The New T41 V12.7 Boards.

What's new… and why the change from V12.6?

April 24, 2026

The new V12.7 board looks like this (module locations in red circles):

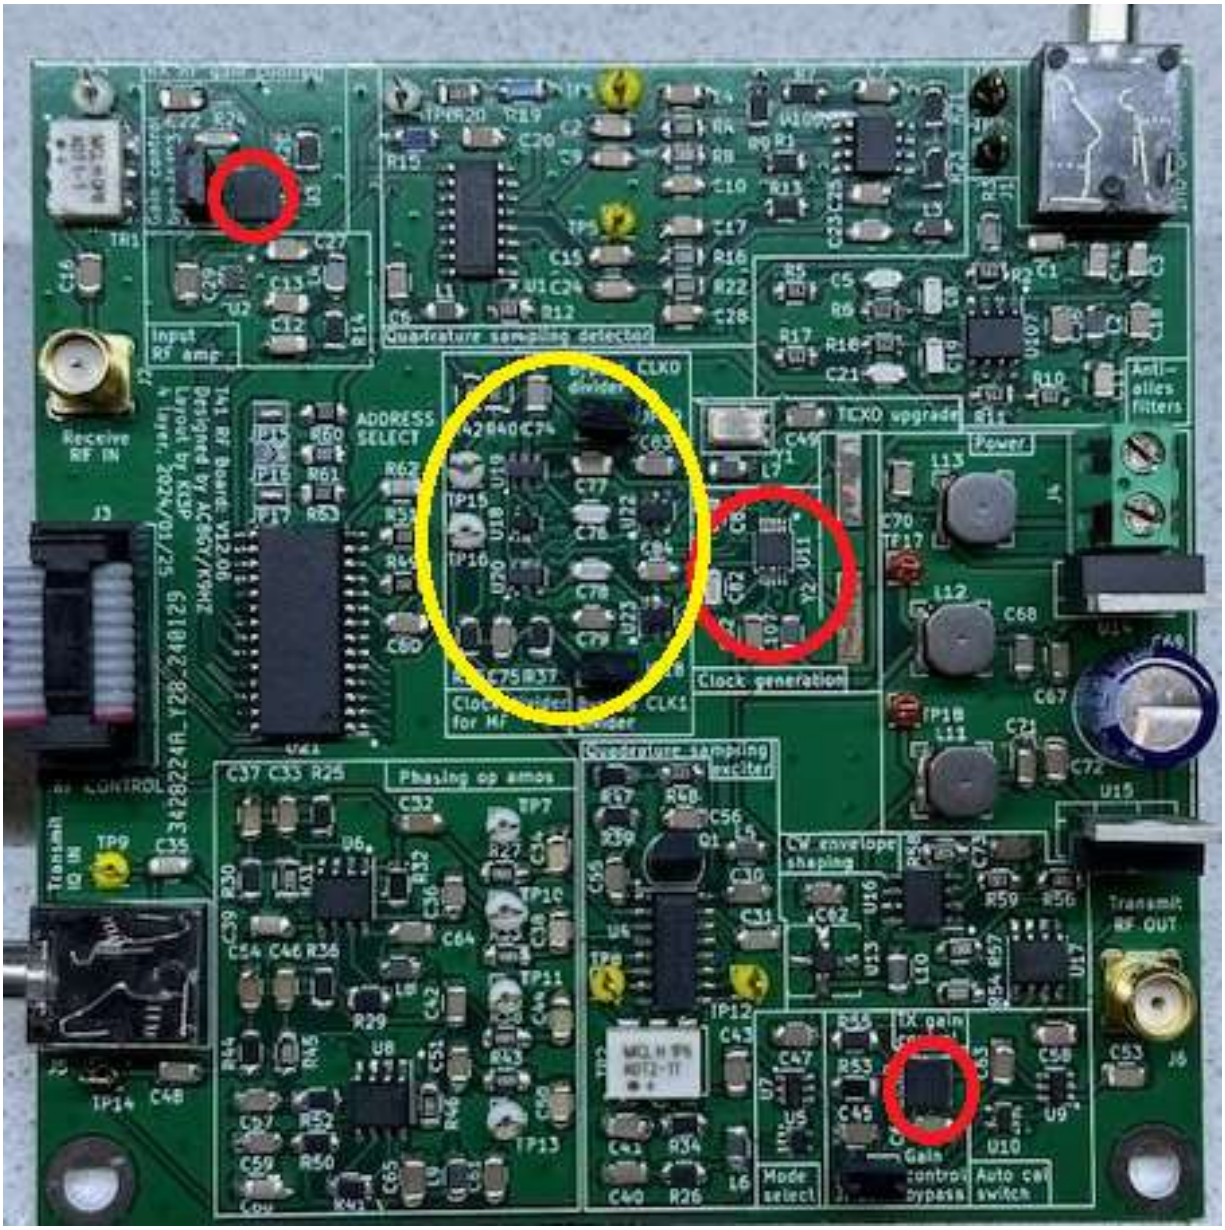
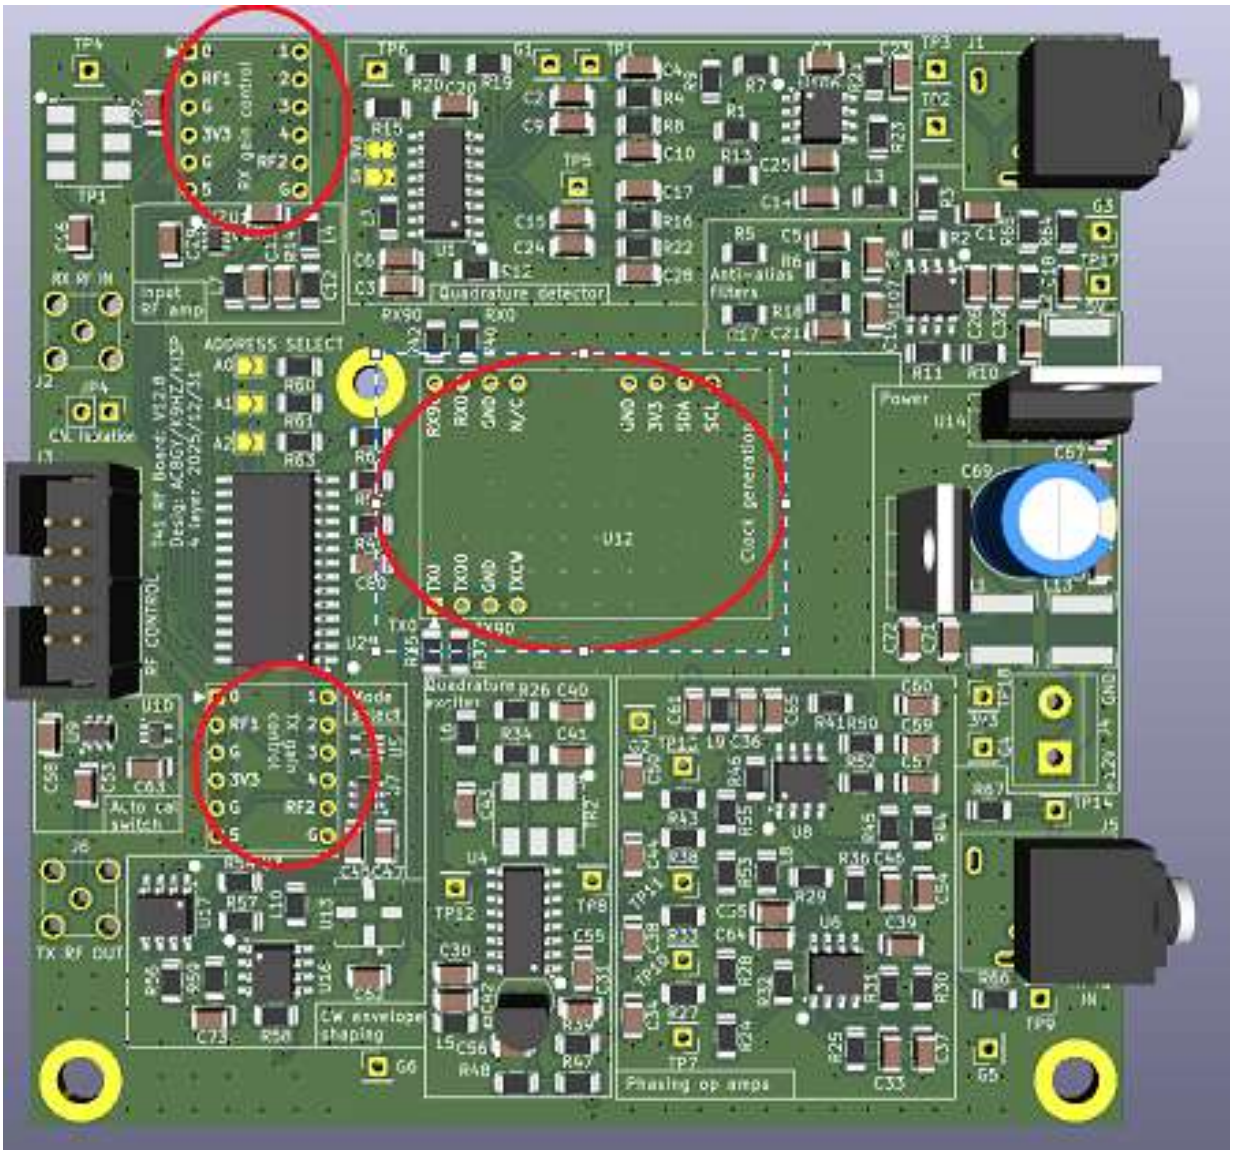
We got a lot of feedback from people building the V12.6 RF board that it was very difficult to mount the PE4212 attenuators (one for receive and one for transmit) on the board due to the small part size (QFN part) and need for hot air solder tools to adequately solder the parts. In addition, we realized that the existing Si4241 clock wouldn't allow for an auto-calibrate cycle where the receiver and transmitter (on the RF board) were both active at the same time (where the calibration cycle could be completely automated). To address these issues… essentially make the T41 V12 radio better, we decided to 1) move these parts these parts to DIP-sized daughter boards that could be (sold) pre-made and easily added by the builder by adding IDC pins, and change to the si5351A-B-GM that has EIGHT separate oscillator outputs…. Enough to generate a clock quadrature pair for the receiver, a pair for the transmitter, and one for CW (with three to spare!)… and that allows the receiver and the transmitter to be on simultaneously… and calibration to be automated. Simply solder some IDC pins on these small daughter boards… solder IDC sockets to the V12.7 RF board, and plug in the daughter cards.

The two PE2312 attenuators and the si5351 oscillator are shown inside the red circles on the board. T he MF circuitry in the yellow circle was also removed from the new V12.7 board because we were able to do this in software and simplify the hardware.

The picture clearly shows the main spot where the main oscillator daughter board goes in the center of the board, and the two places where the attenuator modules go. The new pre-made modules to go into those space look like this:

Single attenuator module:

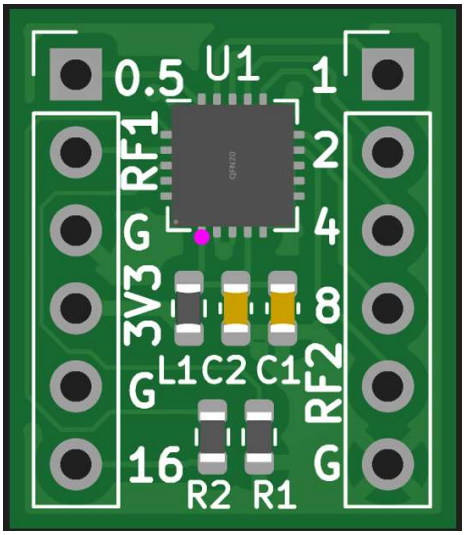
This approach also allows some additional experimentation with the attenuators and oscillator. We've already designed a new twin attenuator board that has two PE4312 chips on it in series that gives a total of 63.5 db of attenuation in 1 db steps instead of the original 31.5 db in 0.5 db steps. This is nice for building an automatic hardware AGC for receive, and for having range in the output power control on transmit. A replacement for the oscillator board could be made using a high precision oscillator like the si5340 that is capable of a much greater frequency range, and more precise native quadrature generation. I suspect we will see some additional creativity as time goes on.
